DART SERVICE INSTRUCTION

TO AMEND INSTALLATION INSTRUCTIONS D350-607-3 Rev.D,
INSTALLATION INSTRUCTIONS D350-607-4 Rev. C AND
INSTRUCTIONS FOR CONTINUED AIRWORTHINESS ICA-D350-607 REV. 6
REF TCCA STC: SH94-14
REF FAA STC: SR00213NY
REF EASA STC: EASA.10016996
REF BRAZILIAN STC: 2007S03-03/-04/-05/-06

A	NEW ISSUE	AJS	14.05.16
REV.	DESCRIPTION	BY	DATE
DESIGN	AJS	DART AEROSPACE LTD HAWKESBURY, ONTARIO, CANADA	
DRAWN	AJS		
CHECKED		DRAWING NO.	REV. A
MFG. APPR.	N/A	DSI 9699	SHEET 1 OF 2
APPROVED		TITLE	SCALE
DE APPR.		LUG REPLACEMENT	NTS
DATE	14.05.16	COPYRIGHT © 2014 BY DART AEROSPACE LTD THIS DOCUMENT IS PRIVATE AND CONFIDENTIAL AND IS SUPPLIED ON THE EXPRESS CONDITION THAT IT IS NOT TO BE USED FOR ANY PURPOSE OR COPIED OR COMMUNICATED TO ANY OTHER PERSON WITHOUT WRITTEN PERMISSION FROM DART AEROSPACE LTD.

FIGURE 1: INSTALLATION OF D4775-041 FWD STRUT

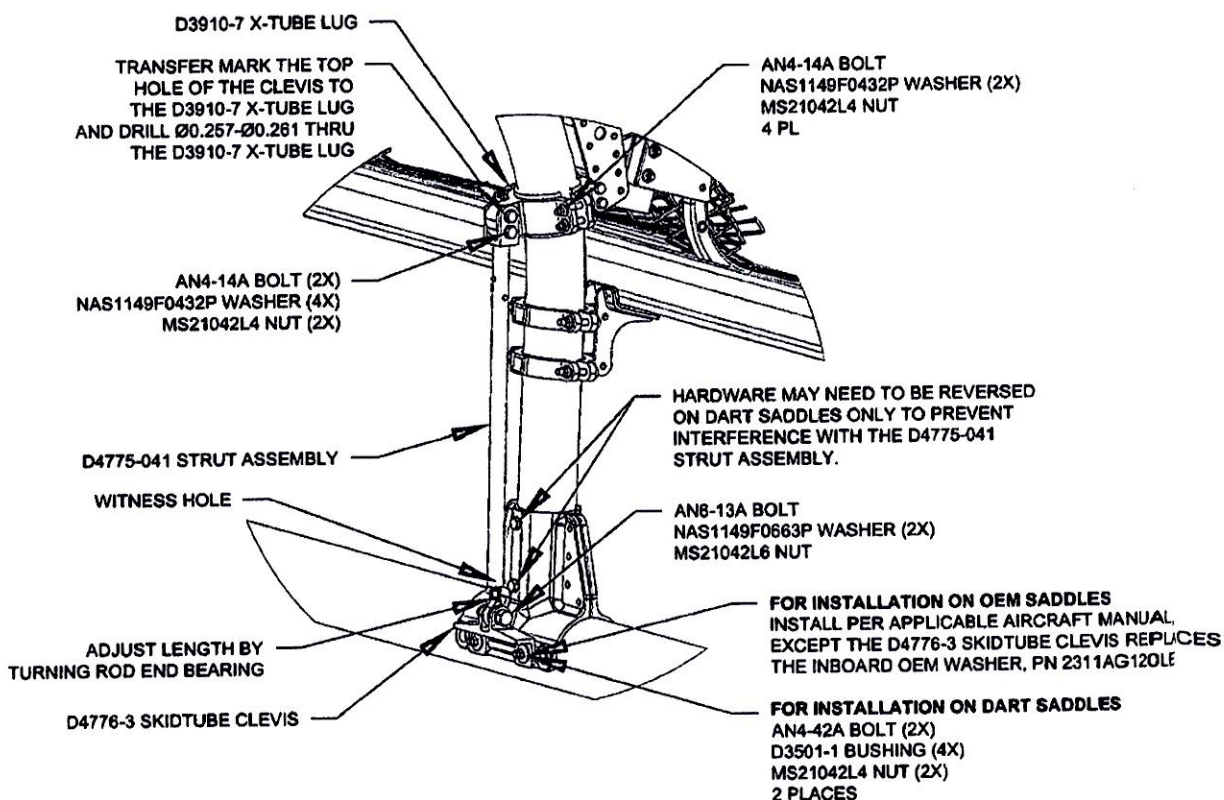
3.1 Substitute the Forward Lower D3910-5 X-Tube Lug with the D3910-7 X-Tube Lug as shown in Figure 1.

3.2 Install the forward D4775-041 Strut Assembly. Transfer mark from the upper hole on the clevis of the D475-041 Strut Assembly to the D3910-7 X-tube Lug and drill thru the lug $\varnothing 0.257$ - $\varnothing 0.261$ as shown in Figure 1. Touch up chemical conversion coating per MIL-DTL-5541. Check the witness holes located at the bottom end of the D4775-041 Strut Assemblies to ensure that the thread from the rod end extends past the witness hole.
Torque MS21042L4/-4 nuts to 50-70 in-lbs (5.7-7.9 N-m). Torque MS21042L6/-6 nuts to 160-190 in-lbs (18.1-21.5 N-m).
